Fourth annual project review report prepared by the Expert Advisory and Review Board

# BEACON

Bentonite Mechanical Evolution

Date of issue of this report: 30/06/2021

Figure 1 Schematic experimental EB layout

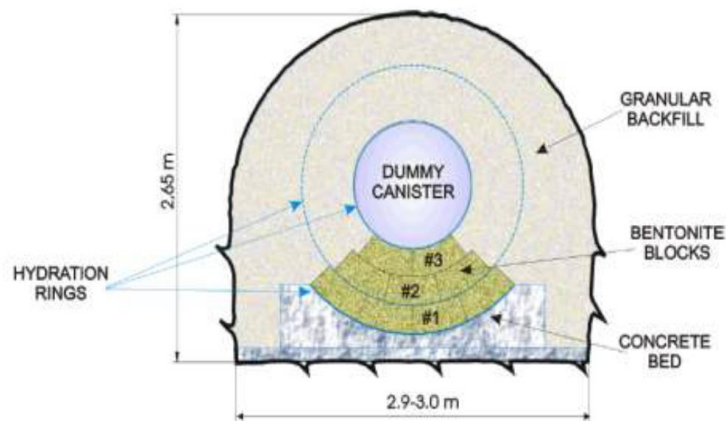
Two modelling teams UPC and ULG made numerical simulations. Difficulties for the modellers are the bad mapping of the initial inhomogeneities in terms of initial dry densities and the lack of close hydration control of the test during the saturation phase.

- UPC took into account the excavation of the gallery and the time until the emplacement of the experiment, ULG not
- ULG used a corrected hydration process to take into account observed leakages, UPC not
- ULG considered alternative study cases taking into account heterogeneities in the dry densities and the hydration process
- initial suction of the blocks: 150 MPa for UPC & 120 MPa for ULG; how is this difference justified?

The conclusion made in the synthesis section 3.4 “*The results obtained by the two partners are in good agreement with the measures. The trend and the amplitude of the measured quantities are in most cases well reproduced.*” does not reflect the results discussions made by UPC and ULG and should therefore be nuanced. Indeed even if both teams allows to reproduce homogenization of the dry density of blocks and pellets, important discrepancies were also noted (see comparative table 1).

2D modelling seems to be a limitation for the simulation of such tests. Need for 3D modelling to simulate such tests should be pointed out.

The overestimation of the vertical movement of the canister during the buffer hydration (60-70mm modelled compared to ~10 mm measured) should be deeper investigated because:

- displacements are key in the understanding of the HM behaviour
- the uplift of the canister is supposed to participate to the homogenisation process

The conclusion made in the synthesis “*This highlights the important role of the interaction functions on the results and specially to estimate the variation of these quantities during the transient phase. On the other hand, introducing a distribution of dry density of bentonite in the initial state or modification of the hydration scheme lead only to slight differences in the results*” suggests that micro-macro interaction functions have more impact than initial dry density heterogeneities on the modelling results. This would need to be further investigated. The low impact of initial dry density heterogeneities seems contradictory with the experimental observations. The potential impact of the non-uniform hydration process and of the heterogeneities in terms of dry densities on the final state should be discussed (e.g. the mechanisms explaining that homogenisation is not complete in the zone of low initial dry density).

Figure 2: Schematic CRT experiment layout

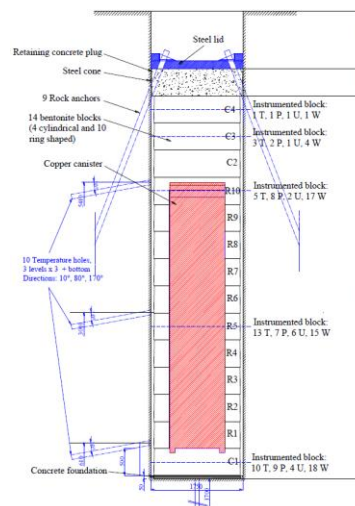
Some differences in terms of boundary conditions and initial state were noted between modelling teams (e.g. initial temperature and porosity of the pellet filled gap). The EARB thinks that the rationale behind these difference should be explained.

A good agreement between the measurements and the models is assessed for the development of total pressure at different locations in the buffer. However the dispersion of the results between the partners is significant. The trends is to overestimate the swelling pressure.

Dispersion of the results between the partners is also significant for the suction evolution. Such dispersion should be discussed more in depth.

The final state in terms of dry density seems to be captured by the different modelling teams. The compression of the outer part of the pellet domain simulated by some modelling teams is however not observed on the measurement results.

Figure 3: Schematic experimental FEBEX layout

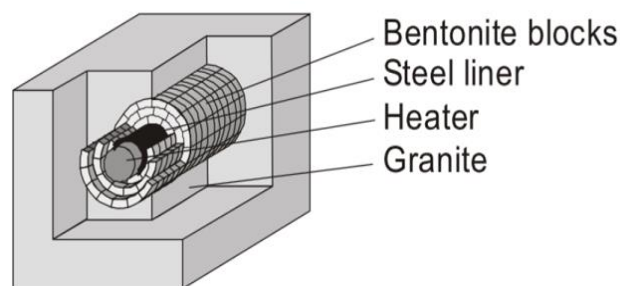
The report indicates that numerical results reproduce the rapid increase of relative humidity in agreement with the measurements. However the results obtained by the modelling teams are dispersed. Dispersion of results are also observed in the simulation of water contents and radial stresses. These dispersion are explained by the importance of the coupling terms between hydraulic parameters and mechanical behaviour. The EARB thinks that the approaches followed to introduce the hydro-mechanical coupling in the models should be compared in order to identify the best approach or areas for improvement.

The report concludes from the comparison between the post-mortem measured quantities and the numerical results presented on Figure 5-106 and 5-107 for S56, that the models give a good estimation of final state. The good assessment of the water content seems however contradictory with the dispersion observed on Figure 5-102.

The EARB considers very interesting that the models are able to reproduce the persisting gradient of density in the material due to the way of hydration happened from the periphery of the bentonite blocks. It would be interesting to investigate if this gradient is persisting on longer period of time.

Figure 1: Schematic view of the experimental set-up

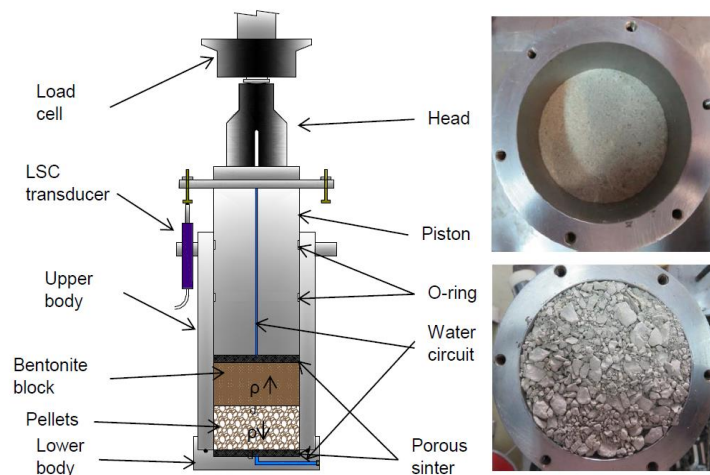
The preparation methods (pouring and shaking) of the pellets parts might induce some structural heterogeneities, which could affect the initial permeability.

It would be interesting to provide the water injection pressure evolution in MGR22 to maintain the constant flow.

The measured axial stress is much lower for MGR27 than MGR22 and MGR23. It would be interesting to investigate if this is an effect of the layers configuration.

The experimental artefact related to the plateau of water intake at 150 cm<sup>3</sup> observed in MGR23 (stop of water intake) should be explained.

# Comparison with Beacon modelling results - in red the above final state calculated values

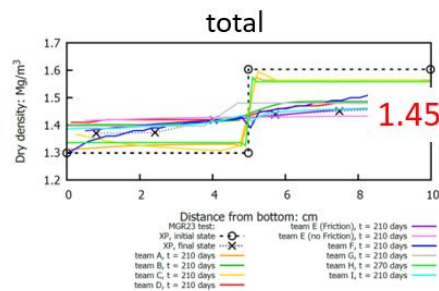
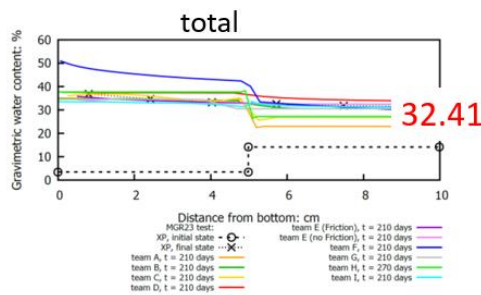
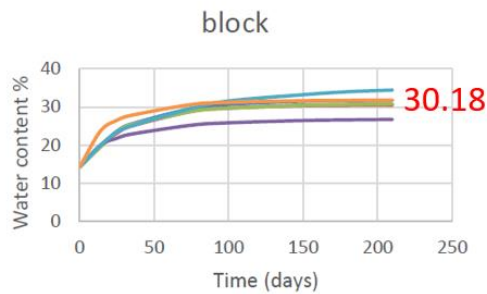
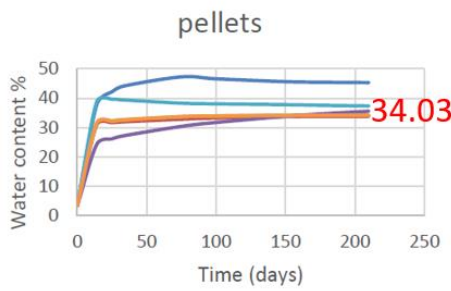
The EARB points out that considering complete saturation and homogenization the final water content can be estimated from analytical solution (see appendix 4).
